# PERMIT

SEWAGE DISPOSAL SYSTEM

A REPAIR

**PROPOSED ADDITION TO  
RANA RESIDENCE**

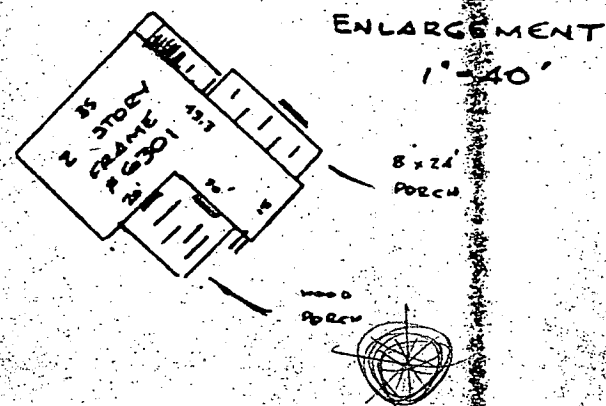
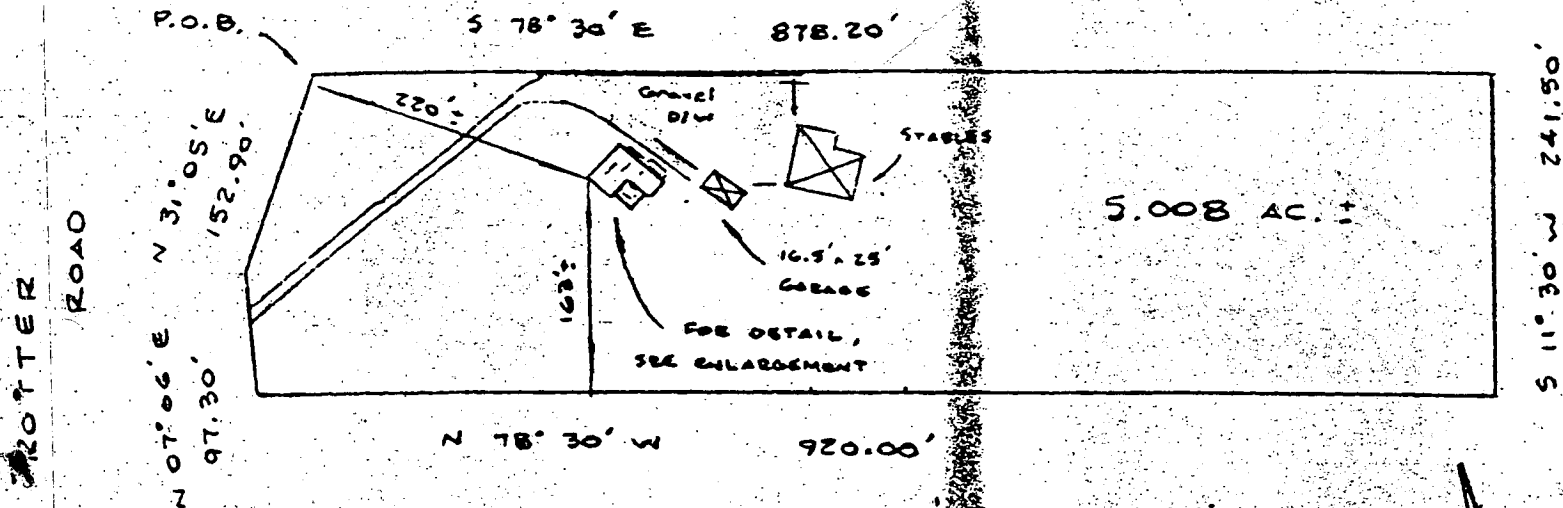
REPAIR - CALL FOR INSPECTION WHEN GROUND IS OPENED UP SO SANITARIAN CAN RECOMMEND REPAIR.

*MOVING SYSTEM TO ACCOMMODATE ADDITION*

*7/26 (1) D well to be 100' + from water well - depth 3 to 4' AT SITE below grade - Depth 10' to 11' (15' x 15') 7' effective 420+ sqft. See back*

**SITE PLAN**

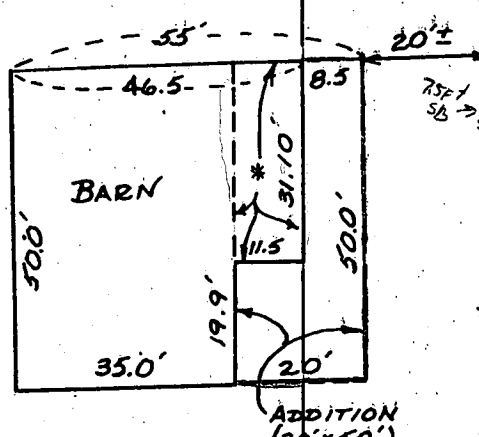
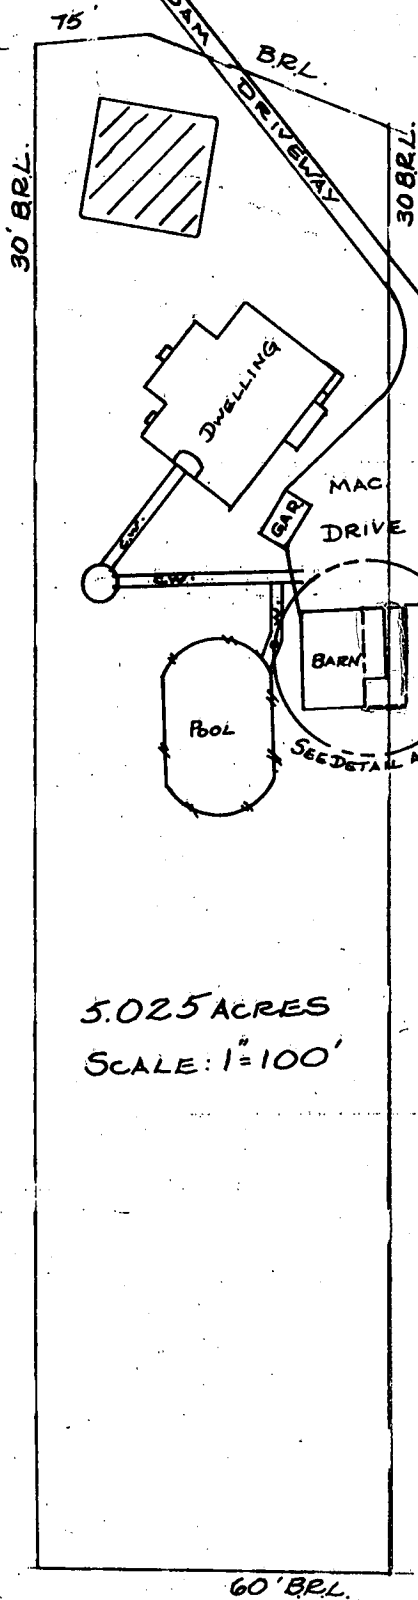
PROPOSED ADDITION  
NO IMPACT TO

WELL OR SEPTIC
